CREDERE ASSOCIATES, LLC

**SUBJECT: Project Peer Review - Former Circle Finishing
US Route 1 Traffic Circle
Newburyport, Massachusetts
MassDEP Release Tracking No. (RTN) 3-0392**

REMAINING UPLAND SOIL SAMPLES AND EXCAVATION LOCATIONS

FIGURE
3

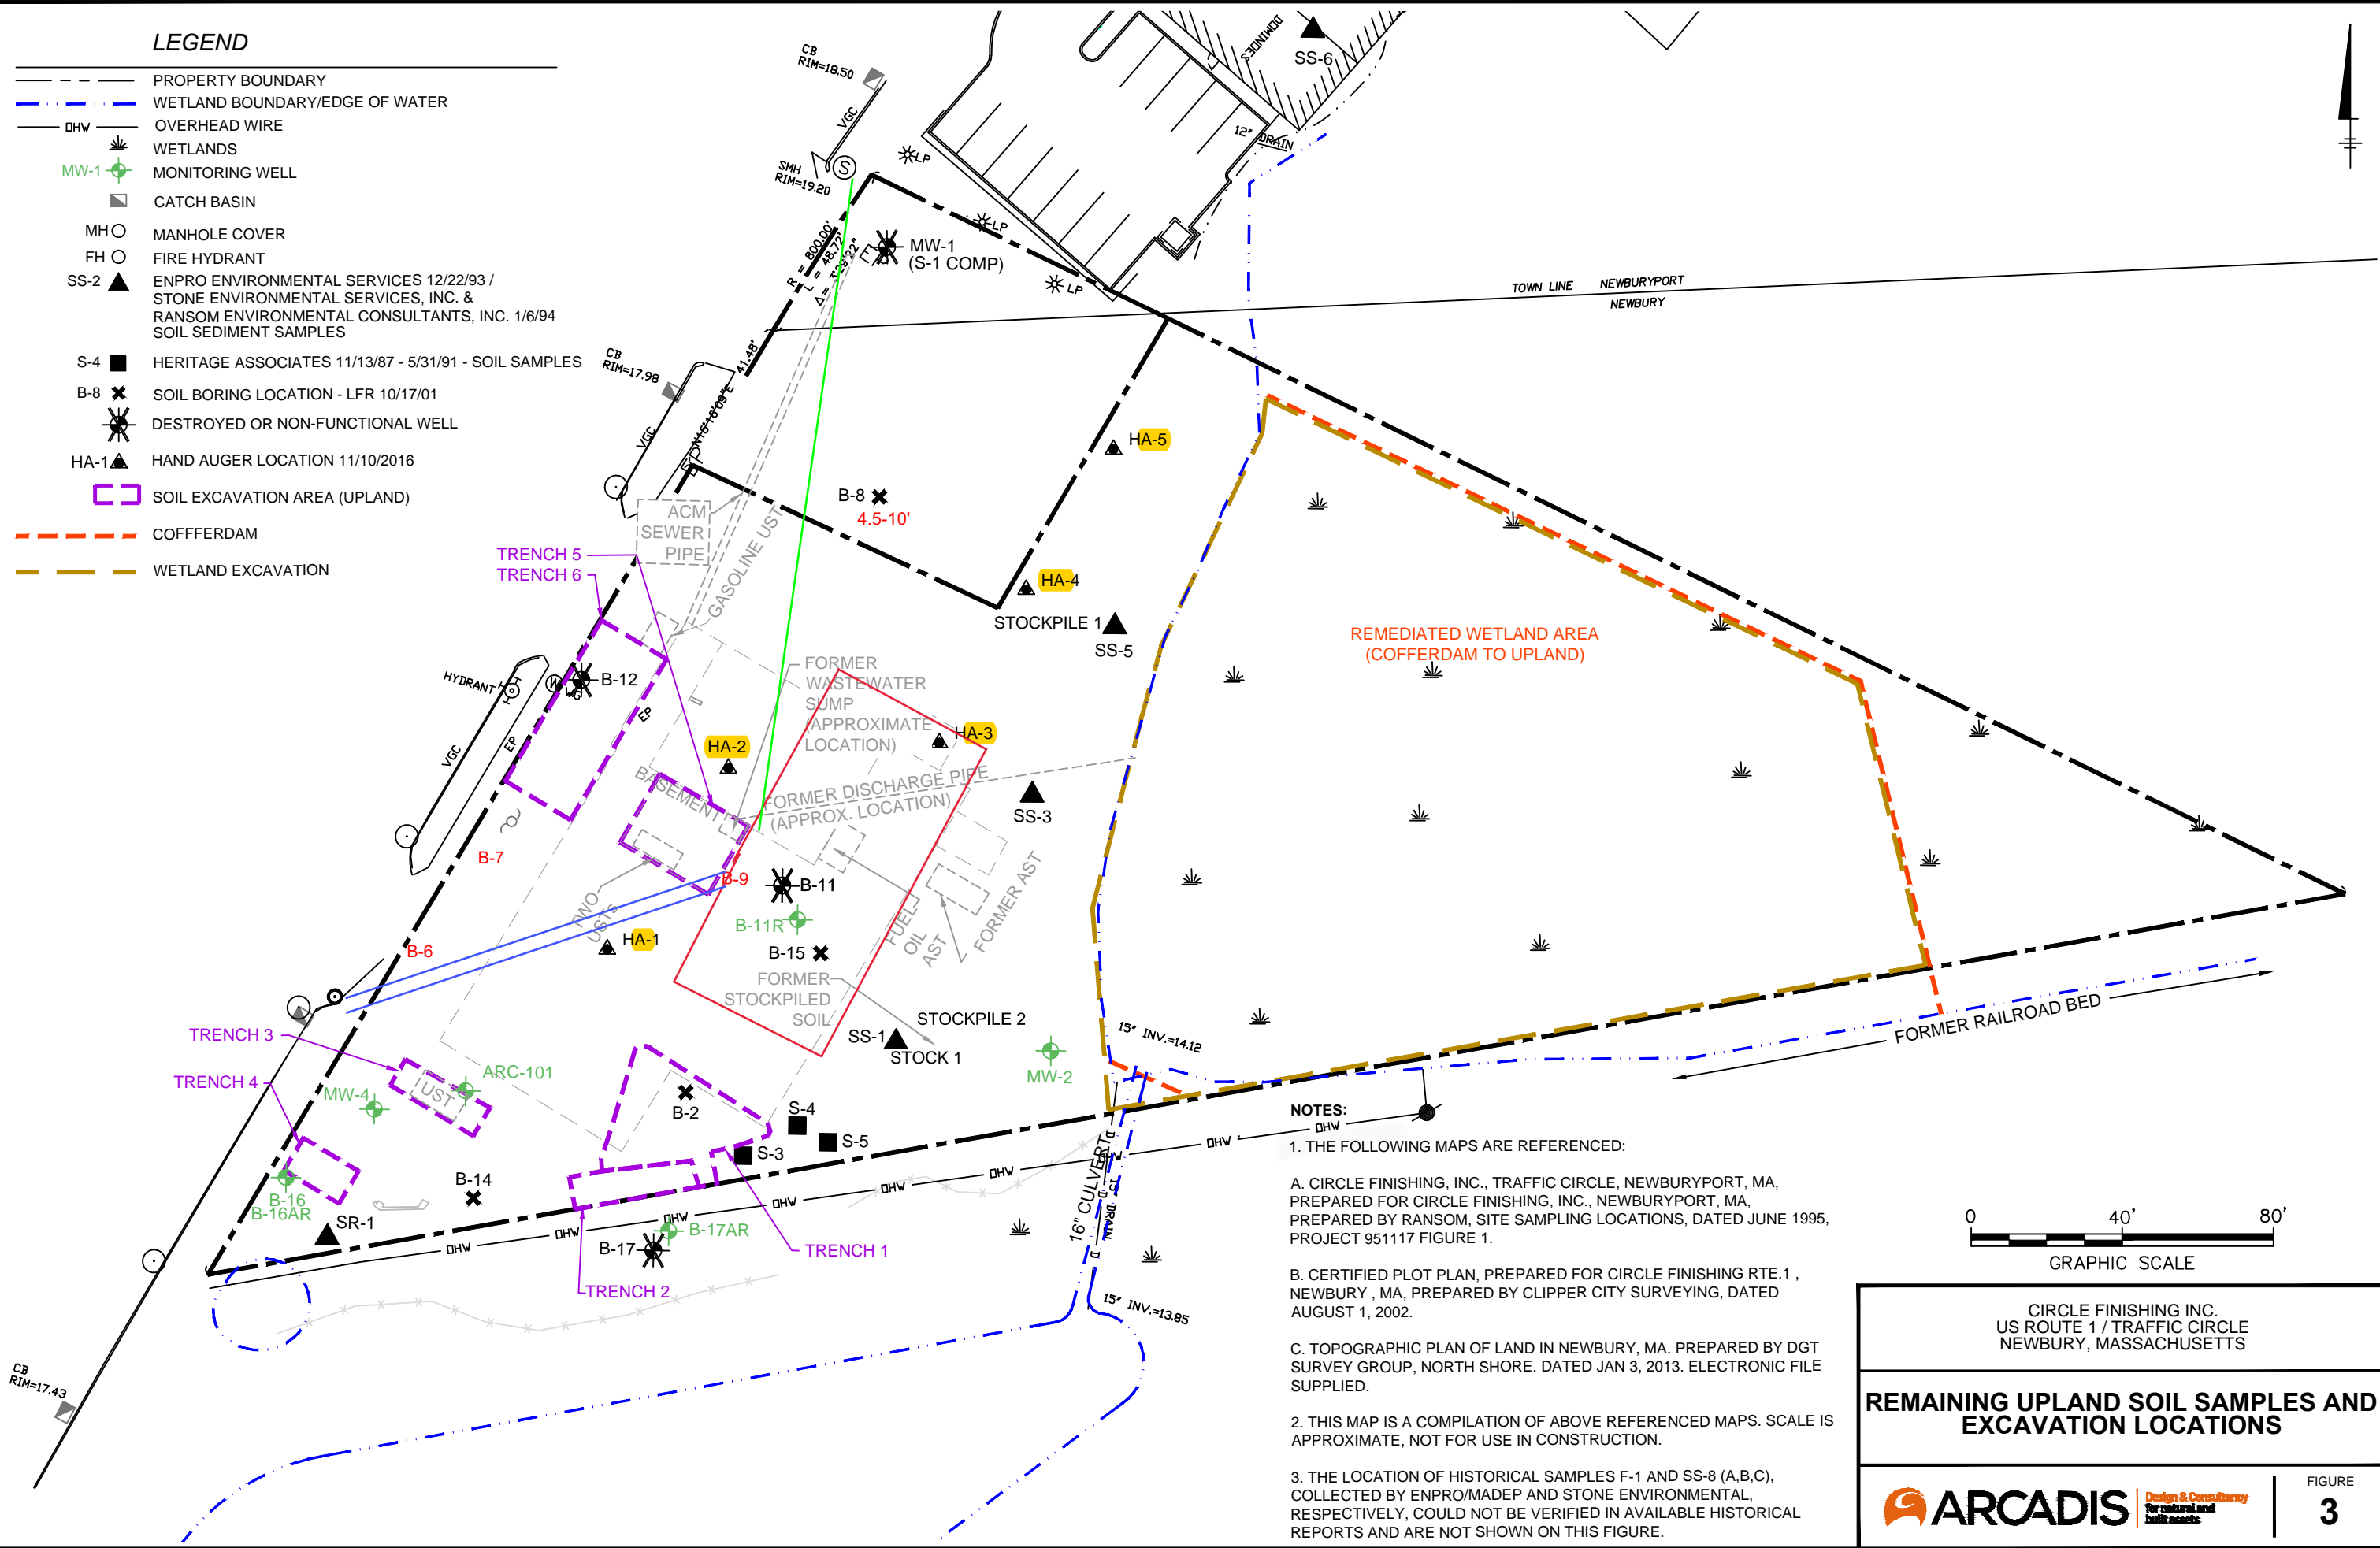
Based on the history of remedial activities, reports suggest there is limited residual contamination remaining in soil at Site. Historical sample location observations and sample results were reviewed to locate samples in closest proximity to the water line and forced main. Based on the requirement for direct bury of the line with 5 feet of cover, the reviewed target depth interval for the pipe was assumed to be between 5 and 7 feet bgs. Specifically, the following sample locations were reviewed:

- B-5: VOC photoionization detector (PID) readings from this boring in 2001 ranged from less than 1 part per million (ppm) from 0 to 4 feet bgs, 413 ppm from 6 to 8 feet bgs and 65 ppm from 8 to 12 feet bgs. Analytical results were limited to a trace detection of ethylbenzene from 5 to 8 feet bgs. Despite the elevated PID result from 2001, the 2014 confirmatory samples from the southern side wall (0-13 feet) and the southern base of Trench 6 excavation were non-detect for EPH and VPH.

- B-6: Metals results from 2001 from 4.5 to 10 feet bgs were non-detect. The soil boring log indicated no evidence of VOCs by PID.
- B-7: Groundwater analytical results for VPH, VOCs, metals and EPH were non-detect in January 2003. This well is in the upgradient position of the water line. PID results indicate 51.6 ppm from 4 to 8 feet bgs and 1.9 ppm from 8 to 12 feet bgs.

- B-8: VOC PID readings from this boring in 2001 ranged from 3.2 from 0 to 4 feet bgs, 22.6 ppm from 4.5 to 8 feet bgs and 3.2 ppm from 8 to 10 feet bgs.

- B-9: VOC results from 2001 indicate 491 ppm from 1 to 8 feet bgs. This location is on the approximate eastern edge of the Trench 5 2014 excavation. Confirmatory samples from the Trench 5 excavation indicate low levels of VPH along the southern sidewall below the Method 1 Soil Standards.

- B-12 was the location of Trench 6 upland soil excavation in 2014. Confirmatory samples from the base of the excavation at 13 feet bgs and the north and northwest corner of the excavation sidewalls continued to detect VPH fractions in the north end of the trench excavation.

- MW-1 is in the upgradient position of the Site and was historically sampled only for metals in soil with concentrations below the Method 1 Soil Standards.

- HA-1: Elevated chromium above the Method 1 S-1 soil standards was documented at the surface from 0-1 foot in 2016.

A copy of a marked-up figure showing these approximately locations relative to the proposed building and services lines is attached.

Based on review of the above available data for the closest sample points, soil contamination within the vicinity of the water and forced main appears limited and below Massachusetts Method 1 Soil Standards. The exception is the soil along the water main immediately near the building (HA-1 and Trench 5 southern sidewall). Groundwater results for the one well B-7 suggests groundwater upgradient of the water main does not have evidence of significant groundwater contamination that could play a role in potentially impacting water within the water service. The proposed locations of the service lines do appear to be selectively routed where limited historical sources of contamination are present and thereby limited data is available. Lack of data cannot always be construed as indicative of lack of contamination, but in this case, there is limited evidence of sources of contamination in areas of proposed service line locations.
